September 15, 2021

CONTRACT NO. 1749

**PRIMARY TANKS CONCRETE DECKING
RESEALING AND REPAIRS**

ADDENDUM NO. 1

**700-C-01
 PRIMARY TANKS
 PLAN VIEW**

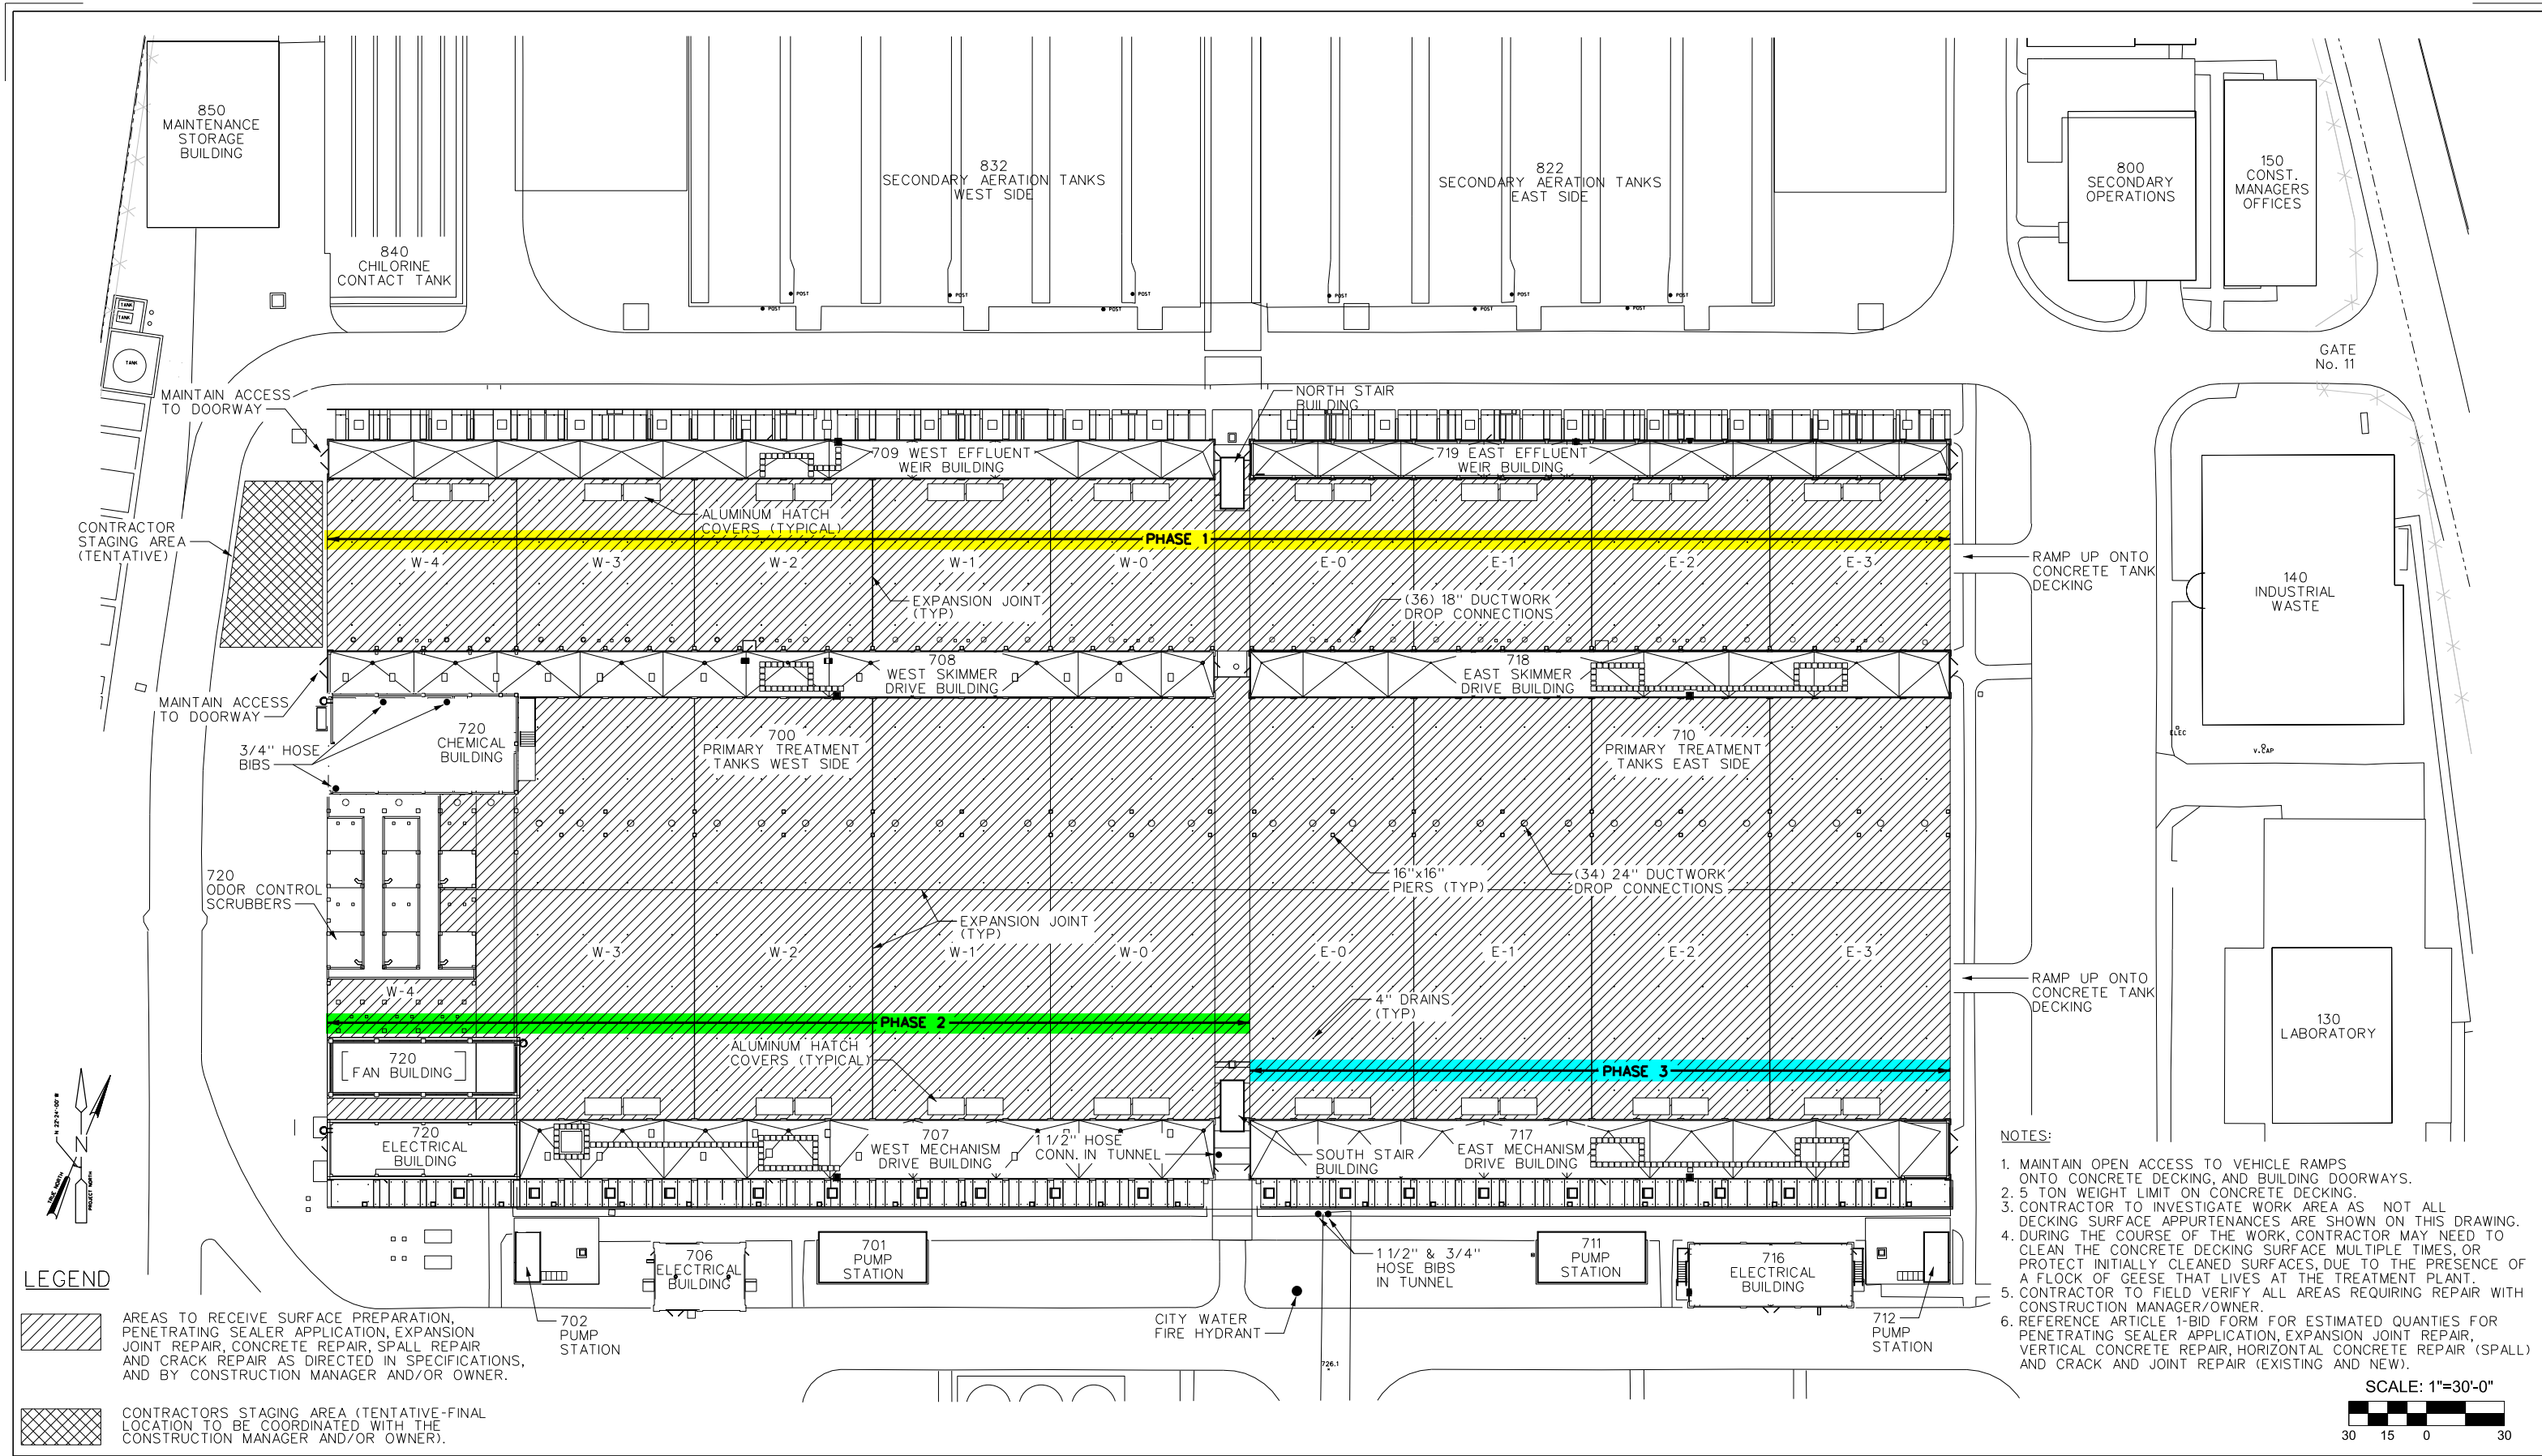
A. DELETE existing drawing 700-C-01; and REPLACE with the revised drawing attached to this addendum.

Answer: There are 3 phases shown on drawing 700-C-01 and noted in the specifications:

Phase 1 includes the area between the Effluent Weir Buildings (East and West) and the Skimmer Drive Buildings (East and West).

Phase 2 includes the area between the West Skimmer Drive Building and the West Drive Mechanism Building.

Phase 3 includes the area between the East Skimmer Drive Building and the East Drive Mechanism Building.

The Phase 1 area is to be completed first. A revised version of drawing 700-C-01 is included with Addendum No. 1, and the Phases are shown in a bolder font and highlighted for clarity.
